Access Compliance Report Public Rights-of-Way (Curb Ramps)

Main Street: BOND_AVE Cross Street: S_CHURCH_ST Location: SE

ADA ID: RPAT211020091155 Ramp Type: Type 1 - Perpendicular Diagonal Initial Pass/Fail: Fail Overall Compliance: No Severity Score: 15

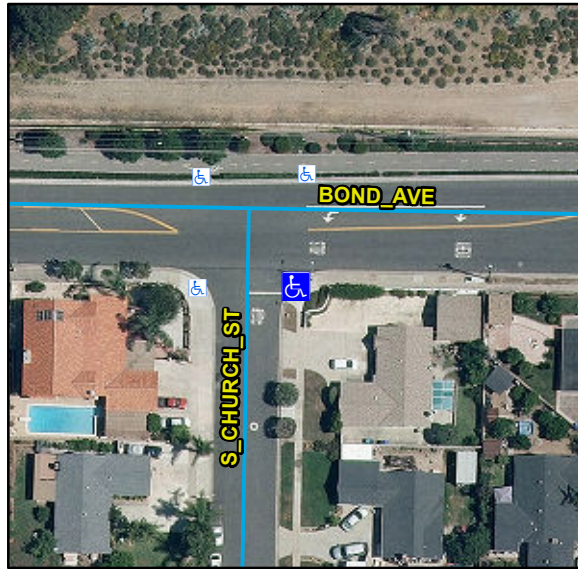
Compliance	Description	Data	Compliance	Description	Data
N/A	Ramp Length (in)	57	N/A	Flare Type LT	
Yes	Ramp Width (in)	48			N/A
No	Ramp Run Slope (%)	9	N/A	Flare Slope LT (%)	N/A
Yes	Ramp Cross Slope (%)	0.9	N/A	Flare Traversable LT	N/A
N/A	Landing Present	N/A	N/A	Flare Type RT	
N/A	Landing Length (in)	N/A			N/A
N/A	Landing Width (in)	N/A	N/A	Flare Slope RT (%)	N/A
N/A	Landing Run Slope (%)	N/A	N/A	Flare Traversable RT	N/A
N/A	Landing Cross Slope (%)	N/A	N/A	DWS Provided	N/A
N/A	Landing Movement Obstructed?	N/A	N/A	DWS Contrast	N/A
	Landing Movement Type	N/A	N/A	DWS Length (in)	N/A
N/A	Landing Shared	N/A	N/A	DWS Full Width	N/A
N/A	Clear Space	Yes	N/A	DWS Offset Left (in)	N/A
N/A	Clear Space To Crosswalk (in)	N/A	N/A	DWS Offset Right (in)	N/A
N/A	Marked Crosswalk 1	No	N/A	Marked Crosswalk 2	No
	Crossing 1 Direction	N		Crossing 2 Direction	W
	Marked Crosswalk 1 Width (in)	N/A		Marked Crosswalk 2 Width (in)	N/A

Remove & Replace Curb Ramp With Two New Directional Ramps or Equivalent.

R304.2.2, STD 1115
